SOLENOID REPLACEMENT

Doc. No.: FI-53

# FIELD INSTALLATION INSTRUCTIONS SOLENOID REPLACEMENT

Figure 1.

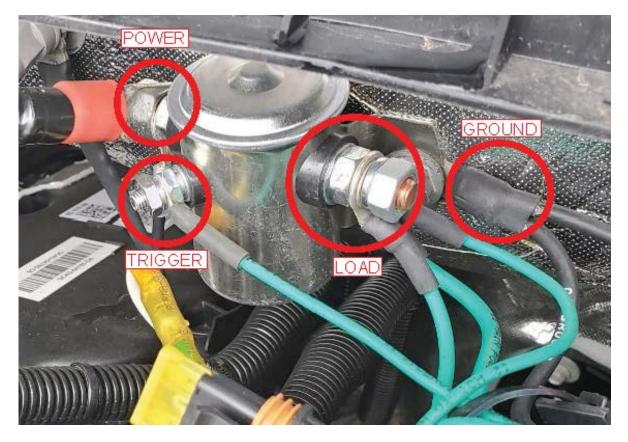
Incorrect: 3-Post Solenoid

- 1. Disconnect the positive (+) and negative (-) wires from the OEM vehicle battery.
- 2. Disconnect the POWER, TRIGGER, and LOAD wires from the 3-post solenoid shown in Figure 1 below.

3. Unbolt the 3-post solenoid from its mounted location and remove the GROUND wires from mounting bolt when applicable. (Set the hardware aside for future use).

**NOTE:** The 3-post solenoid is "case grounded", which is why the GROUND wires are not connected to a post on the solenoid.

Correct: COLE #24059 4-Post Solenoid

- 4. Remove ring terminal connection from the existing ground wire/wires and replace it with a new ring terminal sized for a #10 post.
- 5. Install the new 4-post solenoid in the same location as the existing 3-post solenoid.

**DO NOT** reinstall the ground wires to the mounting bolt as shown in the Figure 1. The new solenoid has a dedicated ground post.

6. Reconnect the existing POWER, TRIGGER, LOAD, and GROUND wires in the locations shown in Figure 2 below.
